LIMIT SWITCH SCHEMATIC

VALTEK
CERTIFIED DIMENSIONAL DRAWING
 NEW YORK POWER AUTHORITY
 JAMES A. FITZPATRICK
 NUCLEAR POWER PLANT

TITLE: 3" ADV-CARBON STEEL BALL VALVE-FLANGED
 4" HAWK END-150# (VBF-20ADV-83) 195/2050V-
 COMPONENT I.D. NO. 63 5 583
 VENDOR: VALTEK
 VENDOR DWG. NO. A-77935.001 SH.1
 FILE NO. 7.65-387

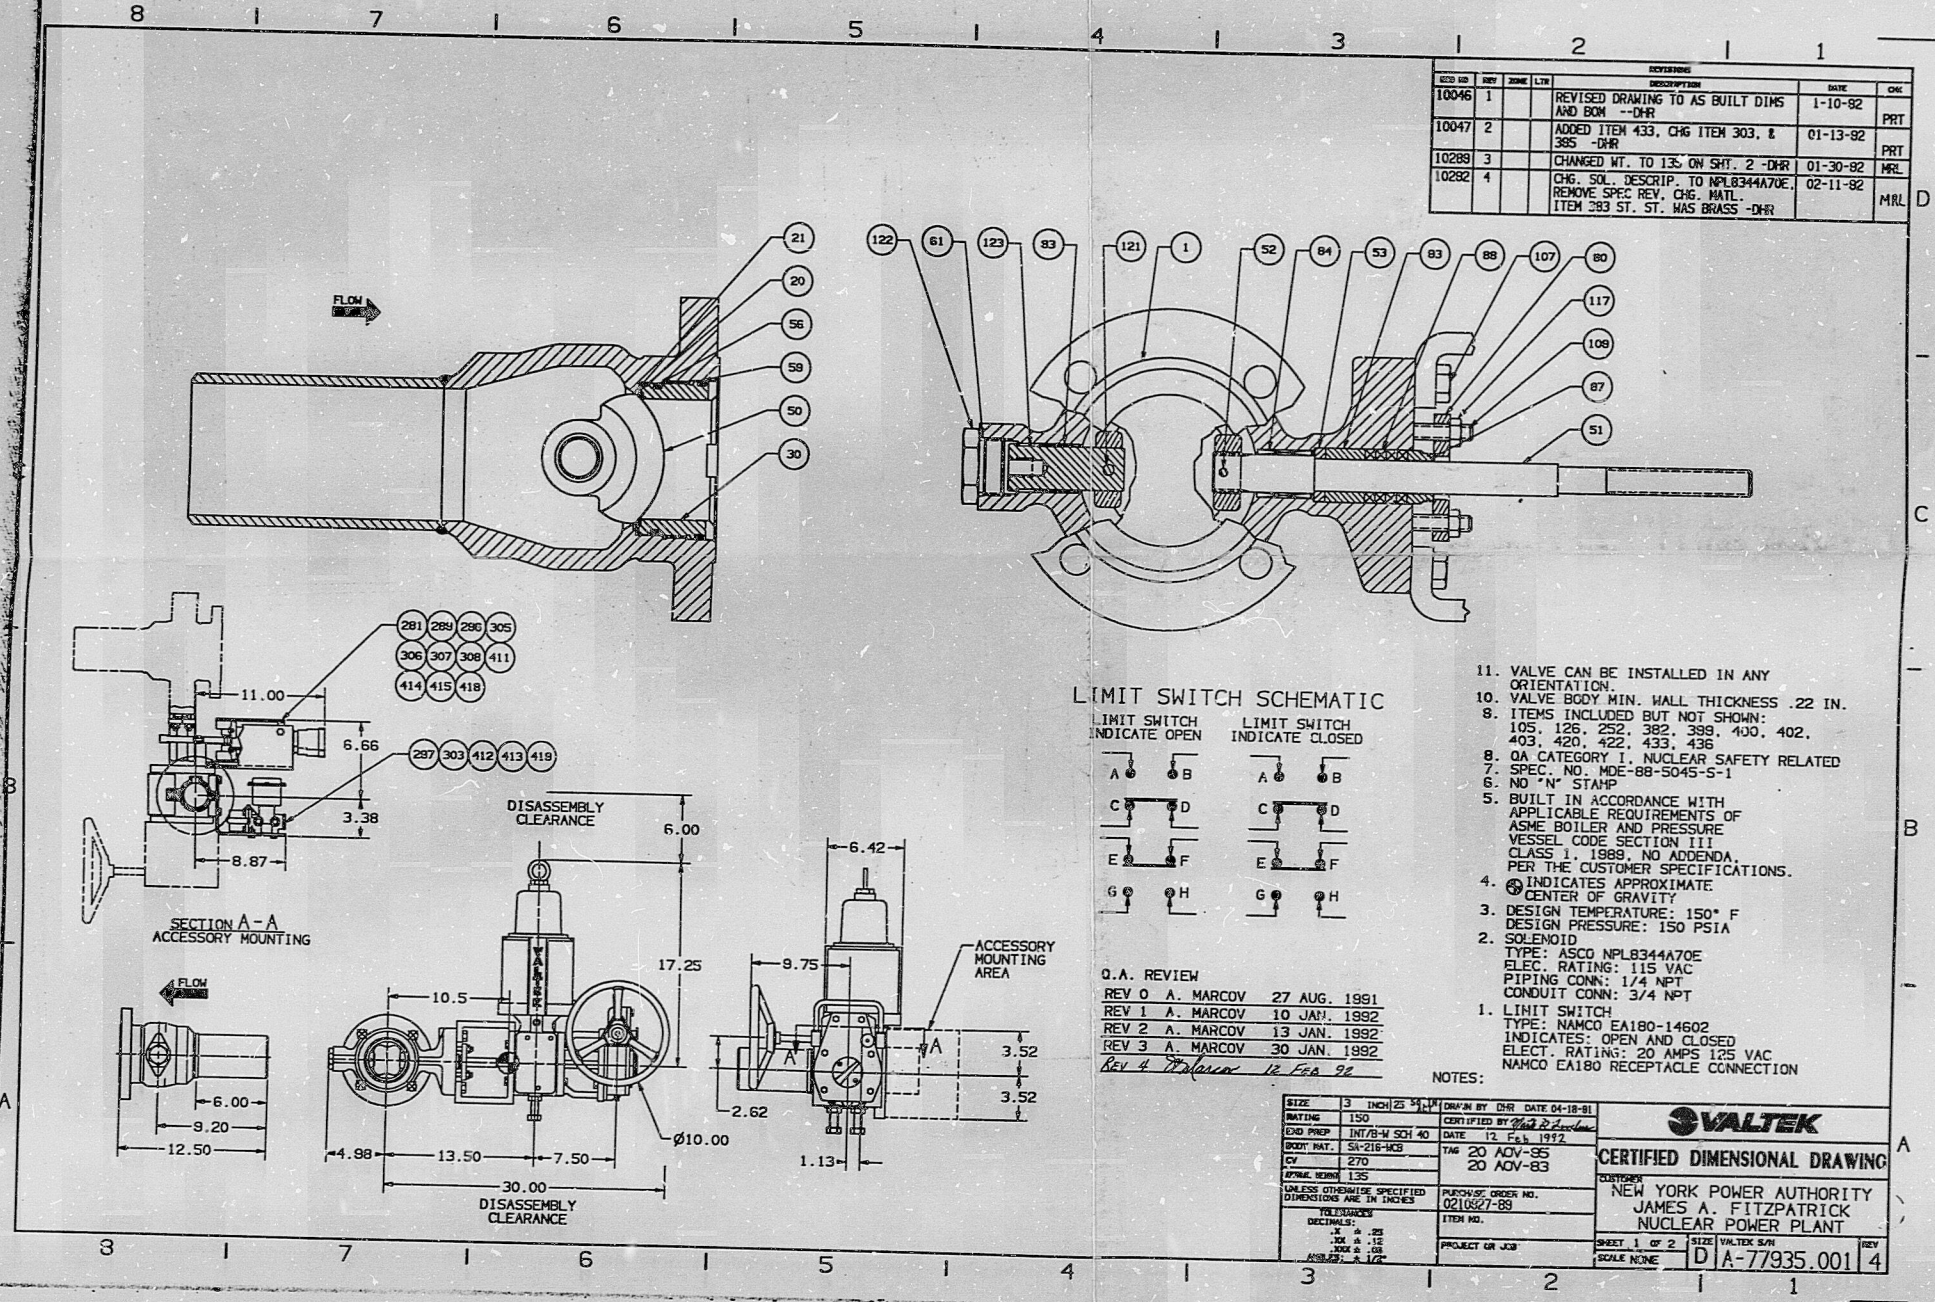
REV	NO	DATE	DESCRIPTION	BY	CHK
10046	1		REVISED DRAWING TO AS BUILT DIMS AND BOM -DHR		PRT
10047	2		ADDED ITEM 433, CHG ITEM 303, & 385 -DHR		PRT
10289	3		CHANGED MT. TO 135 ON SH1. 2 -DHR		MRL
10282	4		CHG. SOL. DESCRIP. TO NPLB344A70E. REMOVE SPEC REV. CHG. MATL. ITEM 283 ST. ST. WAS BRASS -DHR		MRL
